# **CONNECTION ASSESSMENT & APPROVAL PROCESS ASSESSMENT SUMMARY**

**Project: Ramore TS – Build New 115-27.6kV Station**

**CAA ID: 2002-EX059**

**Date: August 23, 2002**

Figure 1

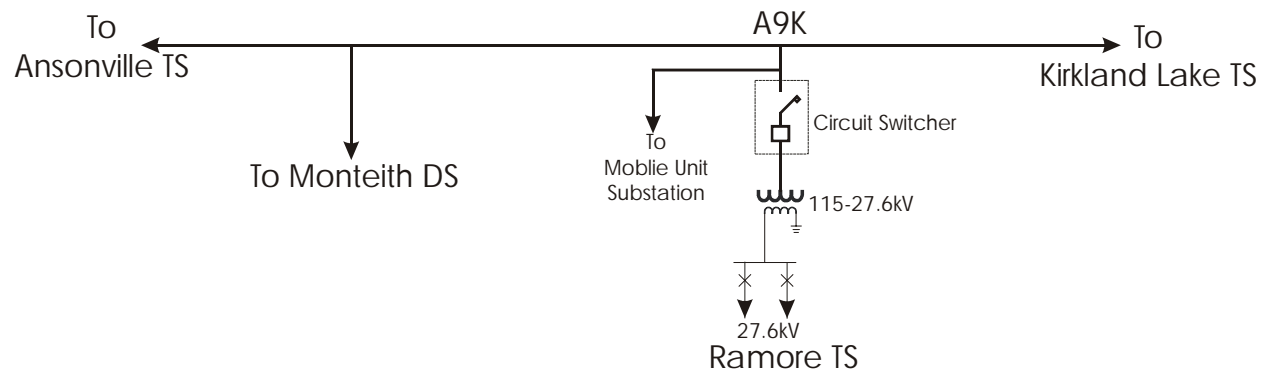
The new transformer impedance is about 8.72% on 10MVA base and is about 20% lower than the impedance of the existing transformer (11.13% on 10MVA base). The short circuit levels at Ramore TS, Ansonville TS, and Kirkland Lake TS will increase slightly. The current short circuit levels at Ramore TS 115kV and 27.6kV buses are about 3500A and 2200A respectively. The short circuit interrupting capabilities of the new Ramore TS, Ansonville TS, and Kirkland Lake TS are well above the expected short circuit levels in the area.

The addition of circuit switcher as the high voltage interrupting device is an improvement in the isolation of Ramore TS station fault over the existing arrangement of relying on coverage provided by A9K line protection.

There is no under frequency load shedding (UFLS) scheme at the existing Ramore TS and HONI is not proposing to install any UFLS at the new station. It has been decided that UFLS is not required at Ramore TS at this time. IMO periodically review the UFLS requirements in the system and will inform HONI if in the future it is deemed necessary to have UFLS at Ramore TS.

This proposal is essentially a like-for-like replacement of existing facilities and will have no adverse impact on the IMO controlled grid.

Based on the above assessment, it is recommended that a Notification of Approval for this proposal be issued to the applicant.
